## **JOSEPH TEAGUE SUBDIVISION**

APPLICATION NUMBER 10 DATE October 17, 2013

REQUEST Subdivision

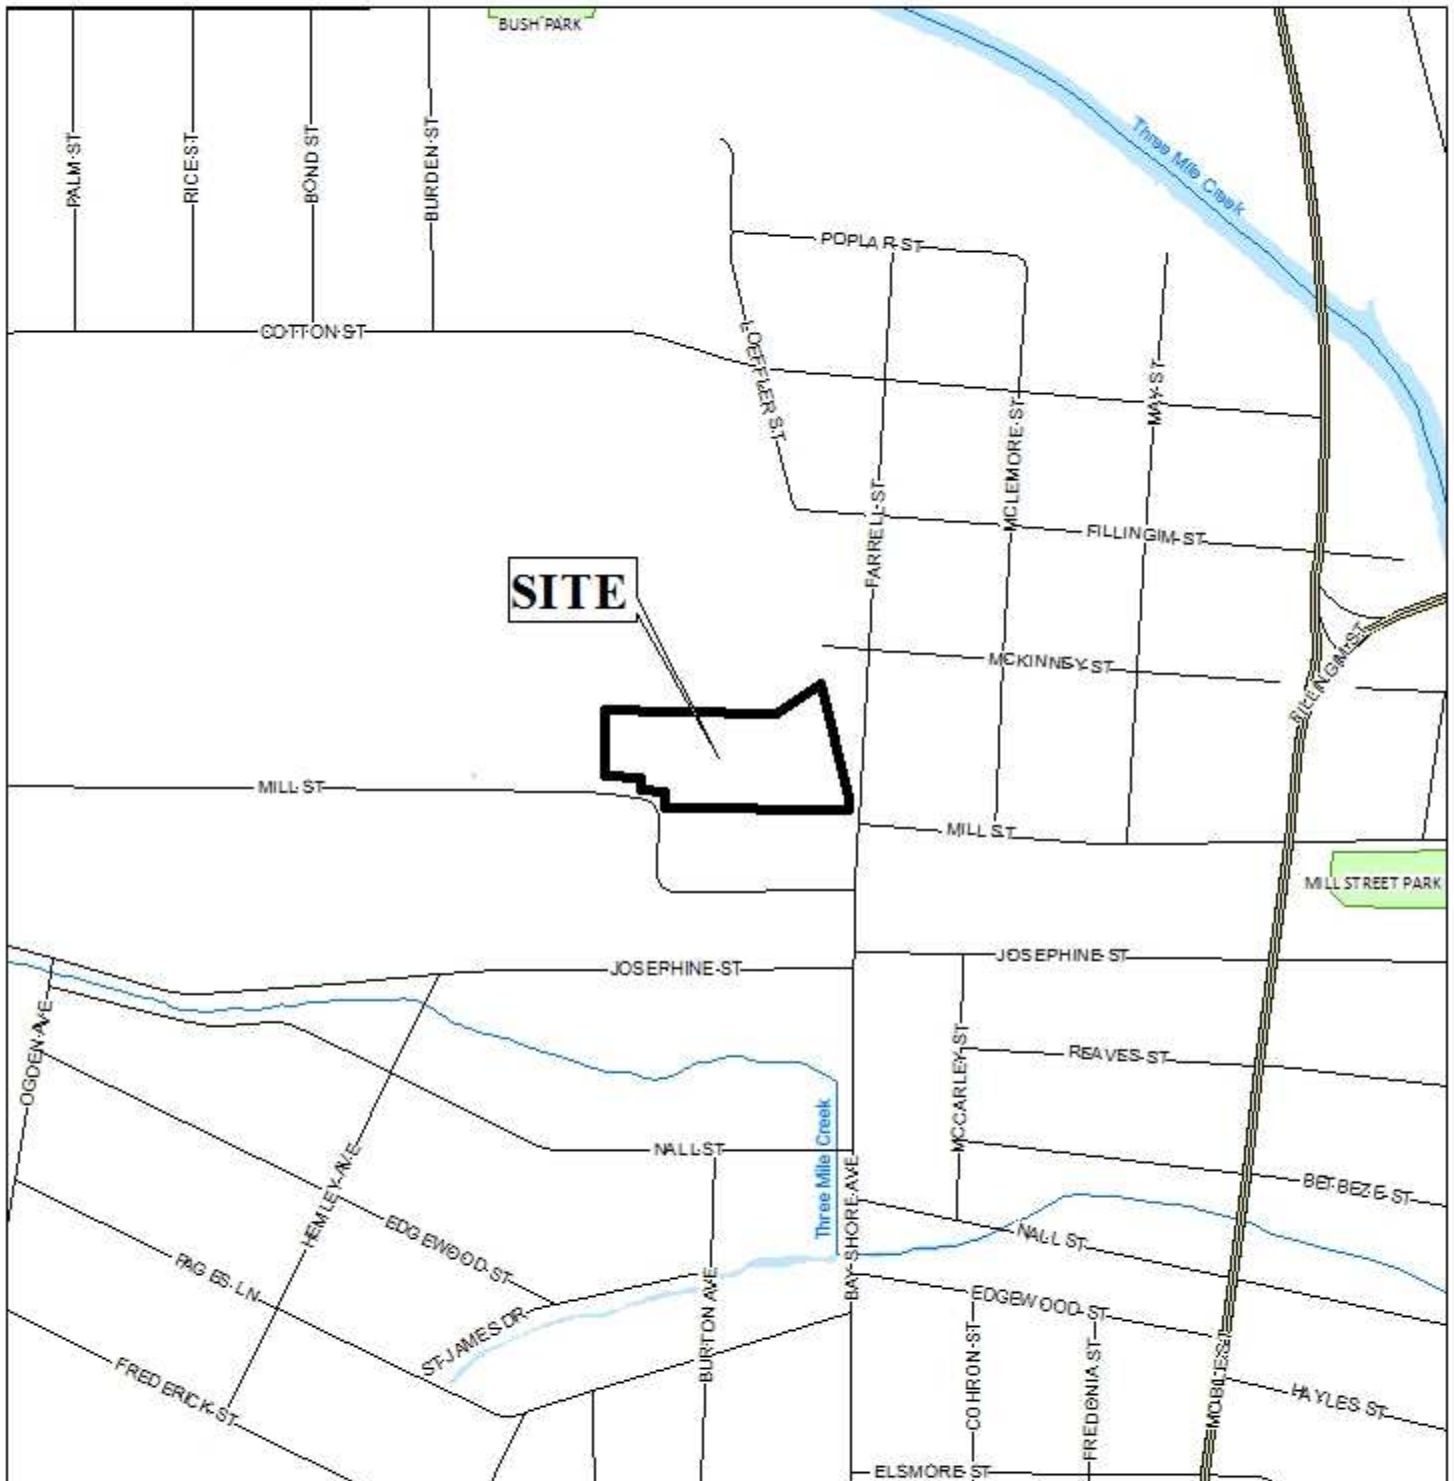
It should be noted that the preliminary plat submitted for review was drawn in 1995, and some aspects of the property configuration have since changed. Also, the engineer/surveyor, Harper & Garrett Engineering, Inc., is no longer in business. Therefore, if this Subdivision is approved, an engineer/surveyor currently licensed must submit a corrected Final Plat for signing.

The proposed lot, as depicted, meets the minimum size and frontage requirements as regulated by the Subdivision Regulations. The area of the site is depicted on the plat as it was at the time of the survey and indicates approximately 3.5 acres. However, that plat indicates that a portion of vacated Illinois Central Gulf Railroad right-of-way to be contained along the East side of the site along Bay Shore Avenue/Farrell Street. City GIS database information indicates that is not a part of the site and is actually under different ownership. This discrepancy should be cleared prior to signing of the Final Plat. The lot should be labeled with its corrected square footage and acreage on the Final Plat, or a table should be furnished on the Final Plat providing the same information

The proposed lot has frontage on two minor streets, Bay Shore Avenue/Farrell Street with a compliant 50' right-of-way, and on Mill Street with a compliant 60' right-of-way; therefore, no dedication would be required. As a means of access management, and as the lot has over 200' of combined street frontage, a note should be required on the Final Plat stating that the lot is limited to two curb cuts, with the size, location, and design to be approved by Traffic Engineering and conform to AASHTO standards. The plat should be revised to illustrate the 25' minimum building setback line along all street frontages.

- 1) preparation of the Final Plat by a currently licensed engineer/surveyor prior to submission for signing;
- 2) revision of the plat to correctly depict the current configuration of the property with the necessary revisions along the East side to depict vacated rights-of-way and/or acquisitions by others;
- 3) revision of the plat to label its size in square feet and acres, or the provision of a table on the Final Plat providing the same information;
- 4) placement of a note on the Final Plat stating that the lot is limited to two curb cuts, with the size, design, and exact location of all curb cuts to be approved by Traffic Engineering and conform to AASHTO standards;

- 5) revision of the plat to depict the 25' minimum building setback line along all street frontages;
- 6) placement of a note on the Final Plat stating that development of the site must be undertaken in compliance with all local, state and Federal regulations regarding endangered, threatened or otherwise protected species;
